# SERVICE BULLETIN No.1173

<b>COACH MODEL</b>	: T2145 and C2045
<b>BULLETIN TYPE</b>	: Service Information
<b>MANUAL &amp; SECTION</b>	: Maintenance Manual: Chapter 5 - Brakes Spare Parts Manual: Section 644709 – ABS
<b>PARTS BOOK REVISION</b>	: Yes
<b>DATE</b>	: December 19, 2005
<b>SUBJECT</b>	: <b>New ABS/ASR sensors on Dana 11.36 drive axle</b>
<b>TERMS &amp; CONDITIONS</b>	: No claims will be accepted with reference to this Bulletin

Figure 1 (left): Physical differences between old ABS/ASR sensor VH 10692775 (1) and the new VH 10796792 (2)

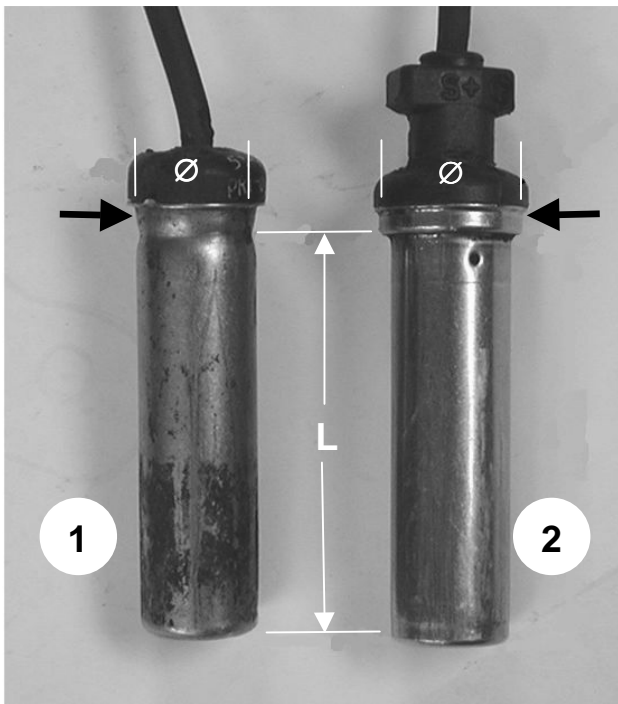
With the introduction of unitized wheel bearings on the Dana 11.36 type drive axle, the ABS/ASR sensors on this axle have been changed. The old and the new sensors are NOT interchangeable, so both are being offered as service replacements.

Figure 2 (below): Stepped sensor VH 10796792 won't fit Dana drive axle 826000. Shoulder prevents it from being pushed home fully.

- Old part # VH 10692775 has been replaced by identical part # VH 10853319.
- Part VH 10853319 and VH 10796792 are NOT interchangeable (see Figure 2).
- Both new parts are available as service replacements.
- Parts may be purchased from your nearest ABC Customer Care & Parts Source dealership.

Part No.	Description	Qty.
VH 10853319	ABS/ASR sensor, Dana 826000 drive axle w/ traditional bearings	2
VH 10796792	ABS/ASR sensor, Dana 826026 drive axle w/ unitized bearings	2
